- C. This license shall be deemed to contain and is subject to the conditions specified in the Commission's regulations set forth in 10 CFR Chapter I and is subject to all applicable provisions of the Act and to the rules, regulations, and orders of the Commission now or hereafter in effect; and is subject to the additional conditions specified or incorporated below:

(2) Technical Specifications

The Technical Specifications contained in Appendices A and B, as revised through Amendment No. are hereby incorporated into the license. The licensee shall operate the facility in accordance with the Technical Specifications.

FIGURE 3.4-2 SEQUOYAH UNIT 2 REACTOR COOLANT SYSTEM HEATUP LIMITATIONS
 APPLICABLE UP TO 14.5 EFY

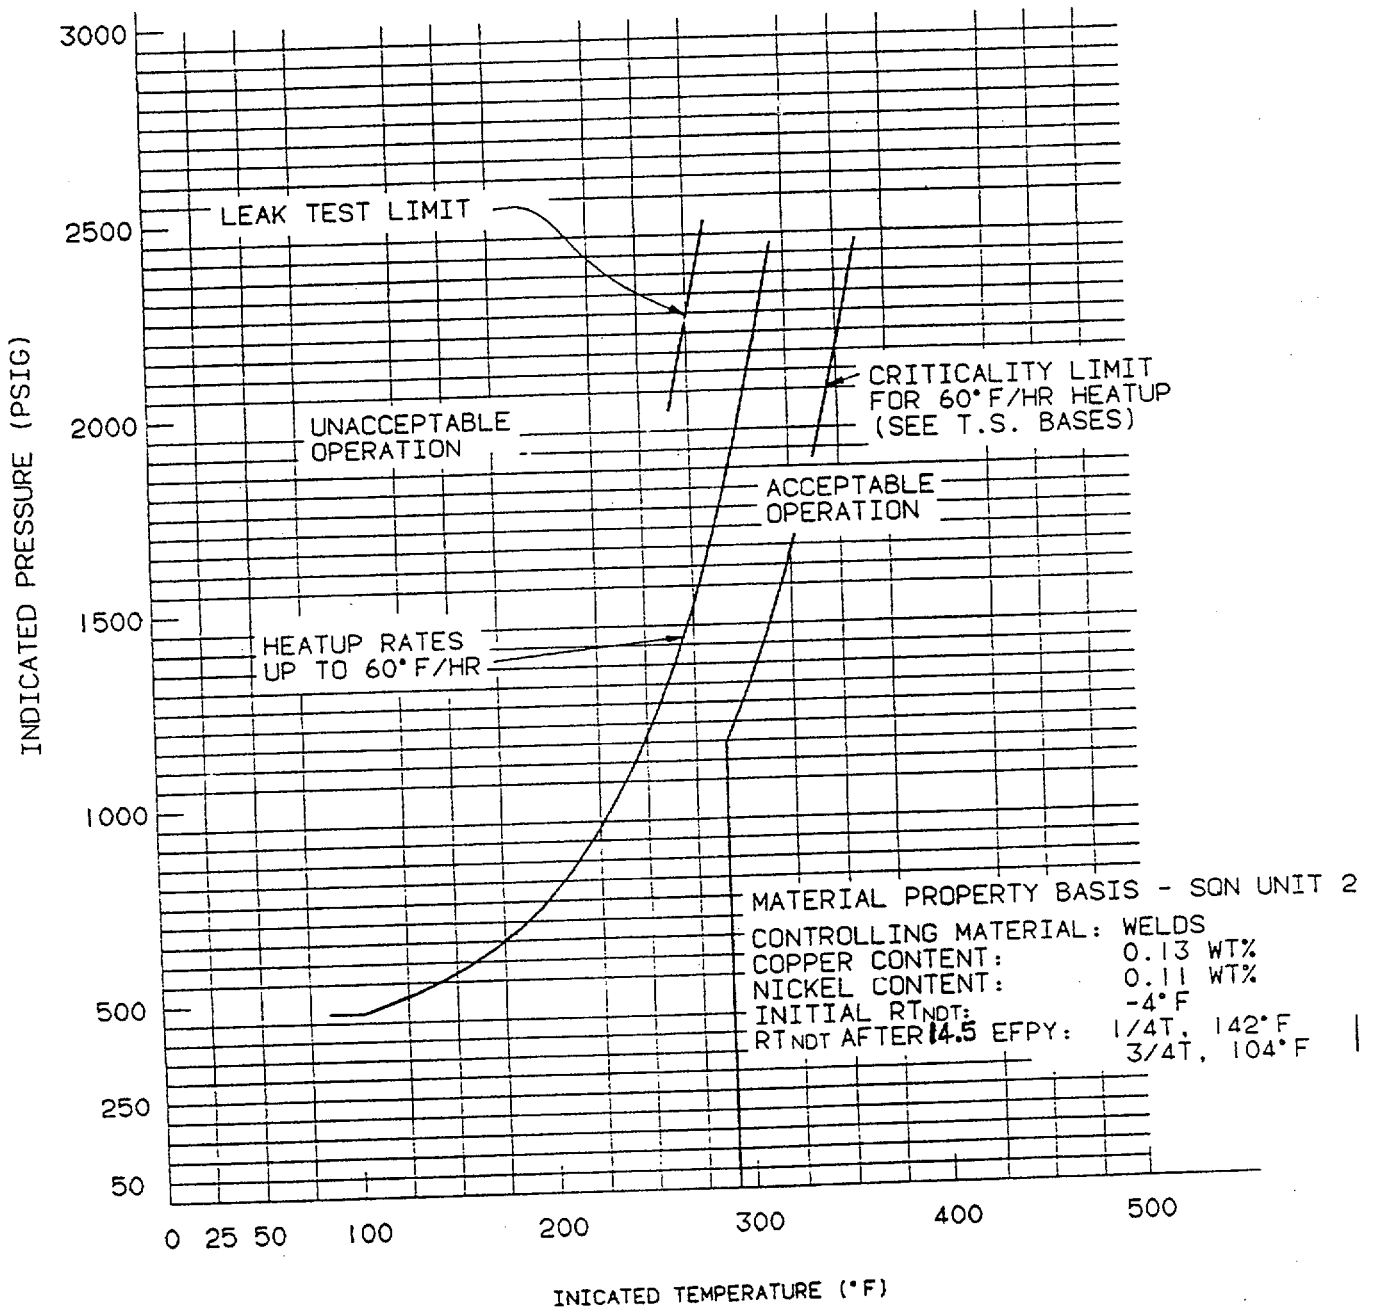
CURVES APPLICABLE FOR HEATUP RATES UP TO 60°F/HR
 FOR THE SERVICE PERIOD UP TO 14.5 EFY. MARGINS OF 60 PSIG
 AND 10°F ARE INCLUDED FOR POSSIBLE INSTRUMENT ERRORS.

10 CFR 50, Appendix G, addresses metal temperature of the closure head flange and vessel regions. Appendix G states that the minimum metal temperature of the closure flange region should be at least 120 degrees Fahrenheit (F) higher than the limiting RT_{NDT} for this region when the pressure exceeds 20 percent of the preservice hydrostatic test pressure (561 pounds per square inch gauge (psig) for Westinghouse Electric Corporation plants). For SQN, Unit 2, the minimum temperature of the closure flange and vessel flange regions is 117 degrees F since the limiting initial RT_{NDT} for the closure head flange is -13 degrees F (see Table B 3/4.4-1). These numbers (561 psig and 117 degrees F) include a margin for instrumentation error of 10 degrees F and 60 psig. The SQN Unit 2 heat up and cooldown curves shown in Figures 3.4-2 and 3.4-3 are not impacted by this regulation.

FIGURE 3.4-3 SEQUOYAH UNIT 2 REACTOR COOLANT SYSTEM COOLDOWN LIMITATIONS
 APPLICABLE UP TO 14.5 EFPY

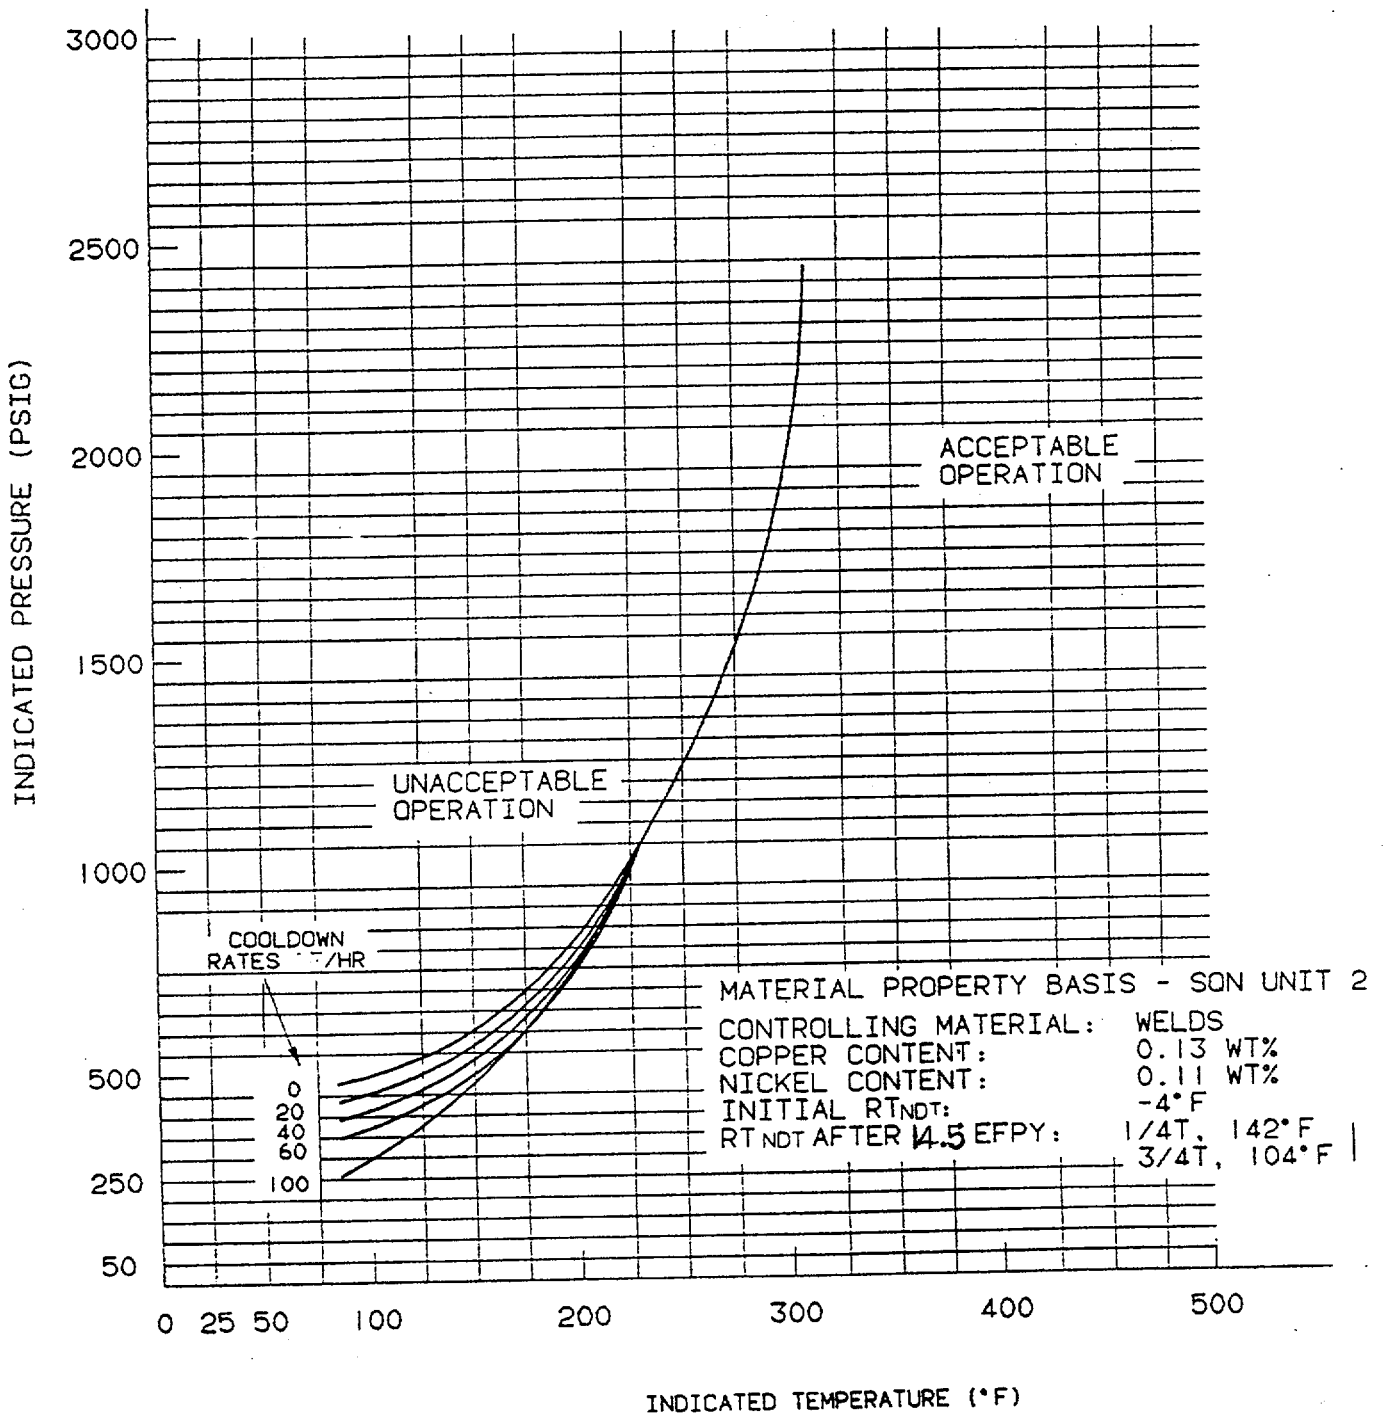
CURVES APPLICABLE FOR COOLDOWN RATES UP TO 100°F/HR
 FOR THE SERVICE PERIOD UP TO 14.5 EFPY. MARGINS OF 60 PSIG
 AND 10°F ARE INCLUDED FOR POSSIBLE INSTRUMENT ERRORS.
